PRODUCT CHANGE NOTICE

1. TITLE IRHNJ7330SE Electrical Characteristics	2. DOCUMENT NUMBER FV5-C-21-0021
	3. DATE August 18, 2021

IRHNJ7330SE [2N7465U3]

400V N-Channel SEE Hardened MOSFET in a SMD-0.5 package

Change Figure 8 Maximum Safe Operating Area curve;

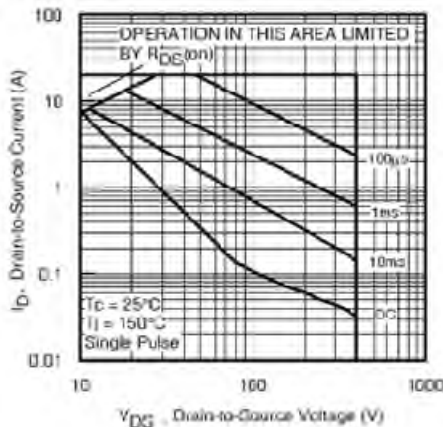
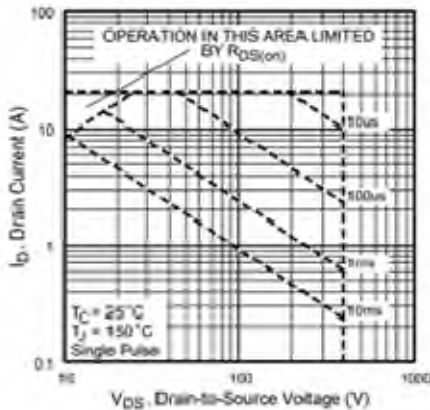
This GIDEP PCN is to announce specification change with the datasheet for the following International Rectifier HiRel Part Number. Note that this change is related to part specification update only by adding SOA DC curve, and not due to a die physical change.
